City of Maple Plain

Request for Site Plan Review, Conditional Use Permits and Preliminary and Final Plat to Allow the Construction of a New Convenience Retail Store, Fuel Station, Car Wash and Associated Site Improvements for the Property Located on Gateway Boulevard

<i>To:</i>	Planning Commission
<i>From:</i>	Mark Kaltsas, City Planner
<i>Meeting Date:</i>	March 7, 2025
<i>Applicant:</i>	Emily Helwig
<i>Owner:</i>	Kwik Trip, Inc.
<i>Location:</i>	Gateway Blvd. (PID No. 25-118-24-11-0040)

RE: Kwik Trip Preliminary/Final Plat and Site Plan Review

Landscape Plan:

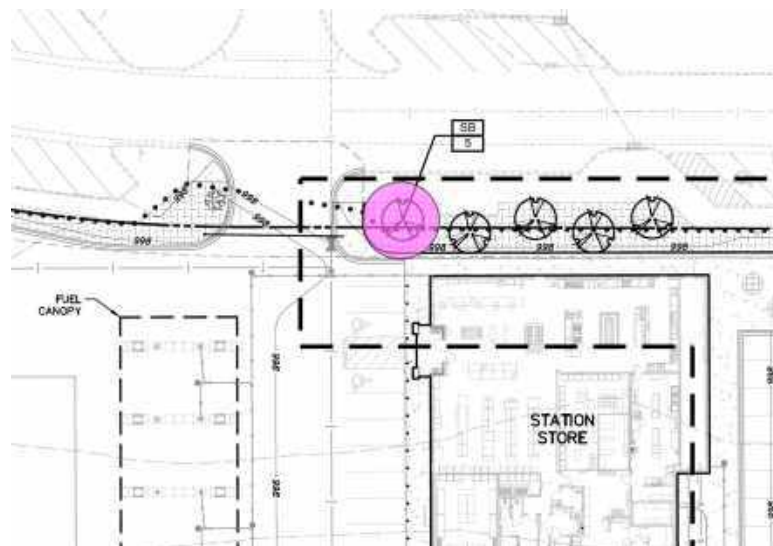
The proposed landscape plan indicates five (5) serviceberries along the north side of the building. As a result of the boulevard tree being removed to accommodate the new drive aisle entrance, it is recommended that one of the serviceberries be replaced with a shade tree (see location below).

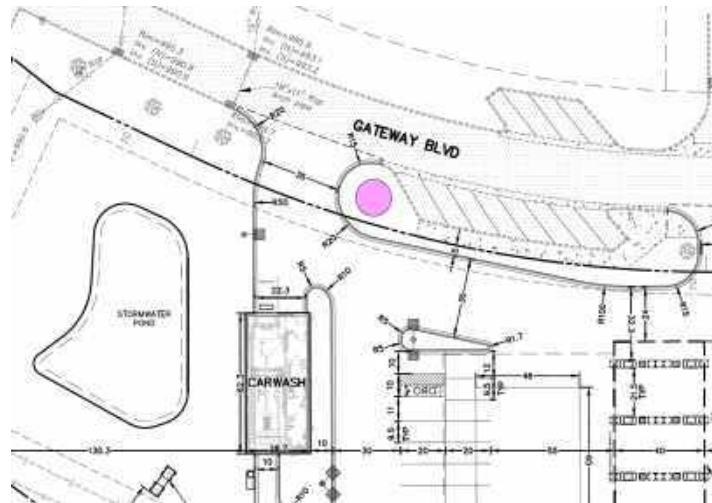
The Maple Plain Fire Department has reviewed the plans and has the following comments:

1. Please indicate the location of the FDC on the site/utility plans.
2. Please indicate the location of the mechanical room on the site/utility plans.
3. The Fire Chief has noted that an additional fire hydrant would be needed to adequately protect this property given the proposed layout and use. MPFD would like to have a hydrant installed in the island shown below (pink circle).

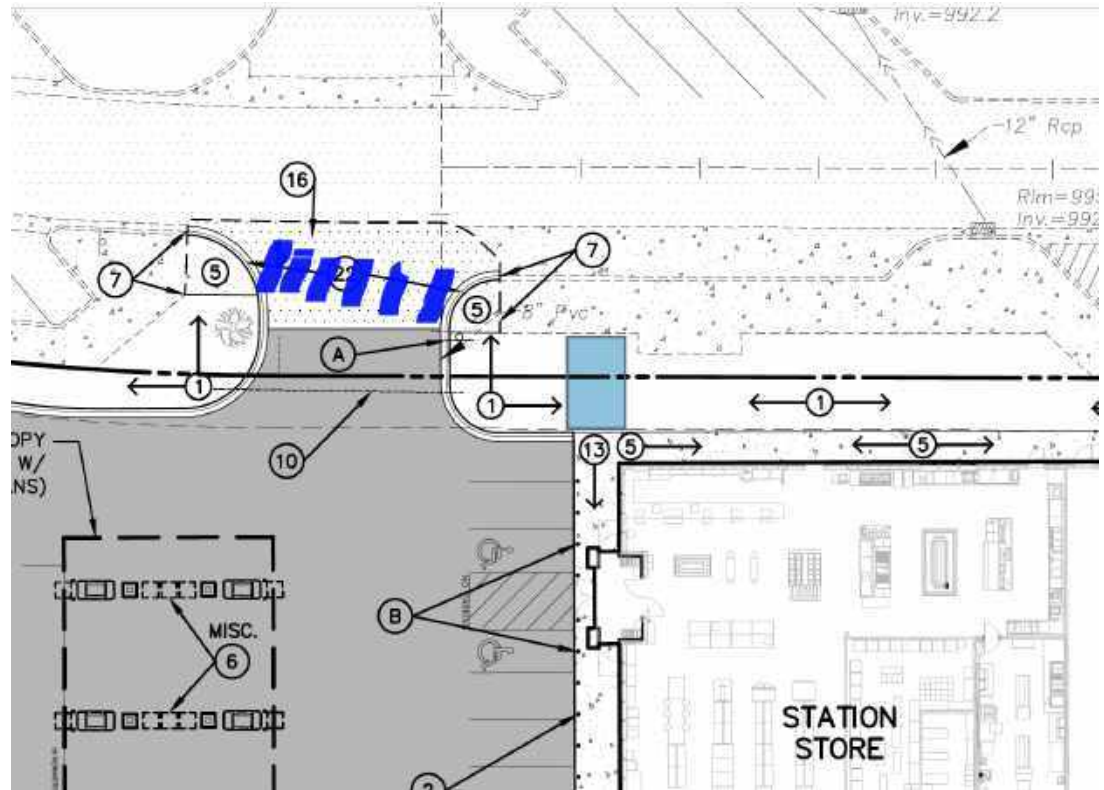
- The plans include a car wash that will have an entrance on the south side of the building. It is anticipated that this car wash will have a high demand and usage due to it being the only one in the area. Staff is trying to determine if there is a way to provide designated stacking (striped line and signage) along the south side of the parking lot to avoid cars waiting behind designated parking spaces (see below). Please review and let's discuss possible solutions.

5. It is recommended that the proposed sidewalk around the building perimeter and the sidewalk in the boulevard be connected (see below).
6. It is recommended that a pedestrian crosswalk be stripped (consistent with drive aisles along Gateway Blvd. – see below).

Landscape Plan/Tree Preservation

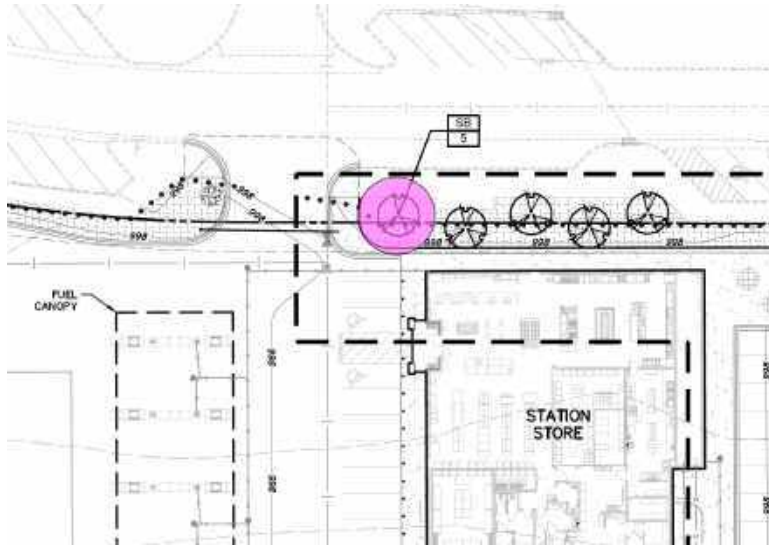
10. The proposed landscape plan indicates five (5) serviceberries along the north side of the building. As a result of the boulevard tree being removed to accommodate the new drive aisle entrance, it is recommended that one of the serviceberries be replaced with a shade tree (see location below).

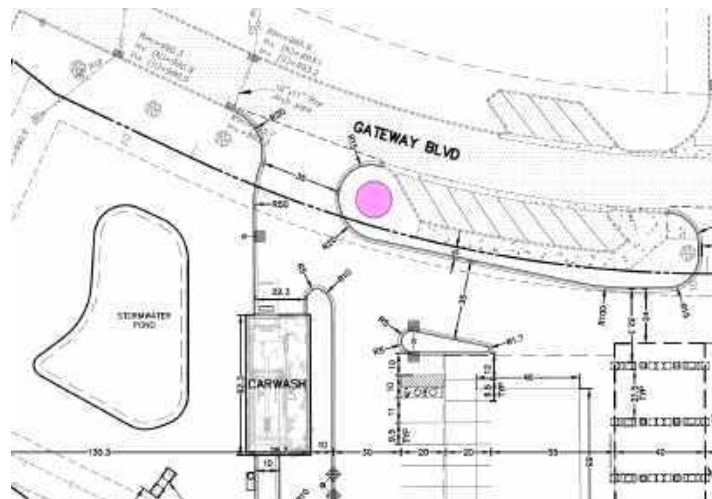
11. The Maple Plain Fire Department has reviewed the plans and has the following comments:
- Please indicate the location of the FDC on the site/utility plans.
 - Please indicate the location of the mechanical room on the site/utility plans.
 - The Fire Chief has noted that an additional fire hydrant would be needed to adequately protect this property given the proposed layout and use. MPFD would like to have a hydrant installed in the island shown below (pink circle).
